<i>to:</i>	Department of Energy	<i>via email:</i>	expartecommunications@hq.doe.gov
<i>from:</i>	Jennifer Cleary		
<i>date:</i>	October 27, 2022		
<i>subject:</i>	Ex Parte Communication; Docket No. EERE-2016-BT-TP-0012

Re: AHAM Supplemental Comments on DOE's Energy Conservation Program: Test Procedure for Dishwashers; Notice of Proposed Rulemaking; Docket No. EERE-2016-BT-TP-0012-; RIN 1904-AD96 and Energy Conservation Standards for Dishwashers, Notification of Availability of the Preliminary Technical Support Document; Docket No. EERE-2019-BT-STD-0039; RIN 1904-AE32

Re: AHAM Comments on DOE's Energy Conservation Program: Test Procedure for Dishwashers; Notice of Proposed Rulemaking; Docket No. EERE-2016-BT-TP-0012-; RIN 1904-AD96

Figure 1: Variability in 2018 Round Robin Testing to Assess Cleaning Performance Score

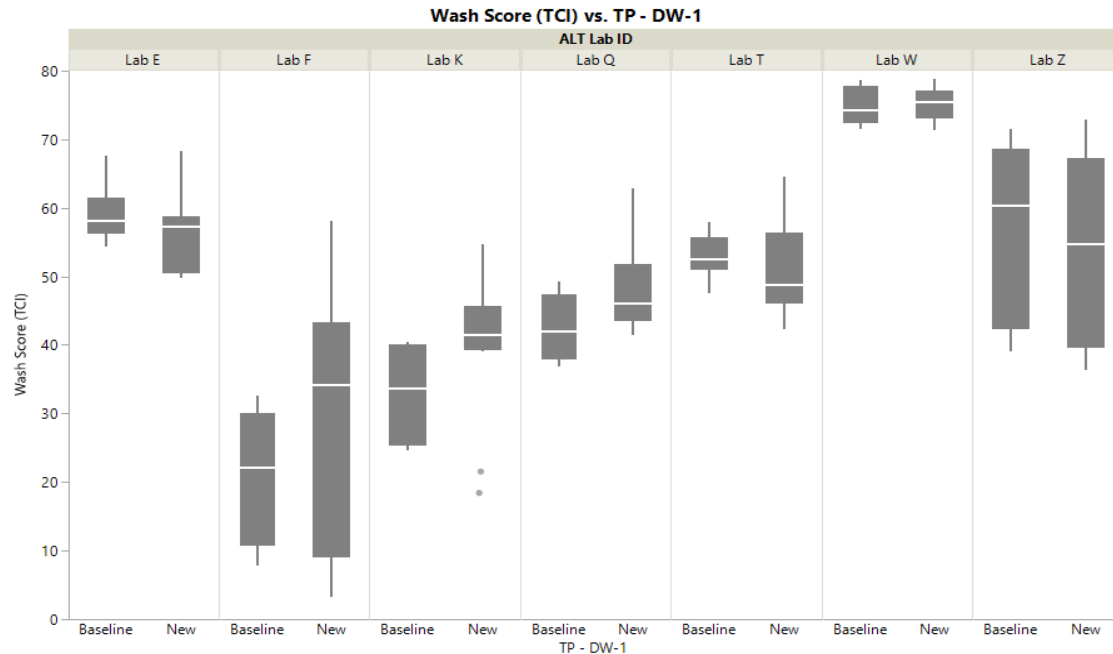
Because AHAM had concerns about the variation of its performance test (then called AHAM DW-1, but now called DW-2) as EPA considered making a performance threshold mandatory for ENERGY STAR eligibility, AHAM and its members endeavored to reduce the test’s variation. Previously, AHAM had demonstrated that the ENERGY STAR test method was highly variable noting that one standard deviation on the cleaning performance measurement was approximately seven points. After making several improvements designed to reduce variation, AHAM and its members conducted round robin testing in 2018 to assess the repeatability and reproducibility of the scoring method in AHAM DW-2. Testing occurred across seven test labs. The results, summarized in Figure 1 below for non-soil sensing units, show the significant variability (even without the machine making sensor decisions)—averaging the standard deviations on the round robin from each row in the red box below yields a standard deviation within lab of 7.7 points.

The data show that DW-2 testing is not sufficiently repeatable to serve as a mandatory regulatory requirement. Nor did the testing demonstrate improved reproducibility. Accordingly, scores using DOE's proposed test procedure would be questionable at best.

These data also demonstrate that scores using the existing ENERGY STAR performance test, and therefore, DOE's proposed performance metric, will be questionable given the level of variation our round robin testing demonstrated, even using the scoring method in DW-2. The actual score could be anywhere in the range the standard deviation between test runs encompasses, meaning that it is possible that a score of 65 could be 76.5 or 53.5 within a single

lab from run to run. Even within a single lab, the same model may pass on one test and fail on another test. This will be compounded if the testing is done across laboratories (even within a single entity, such as two different lab locations within the same manufacturer or third party).
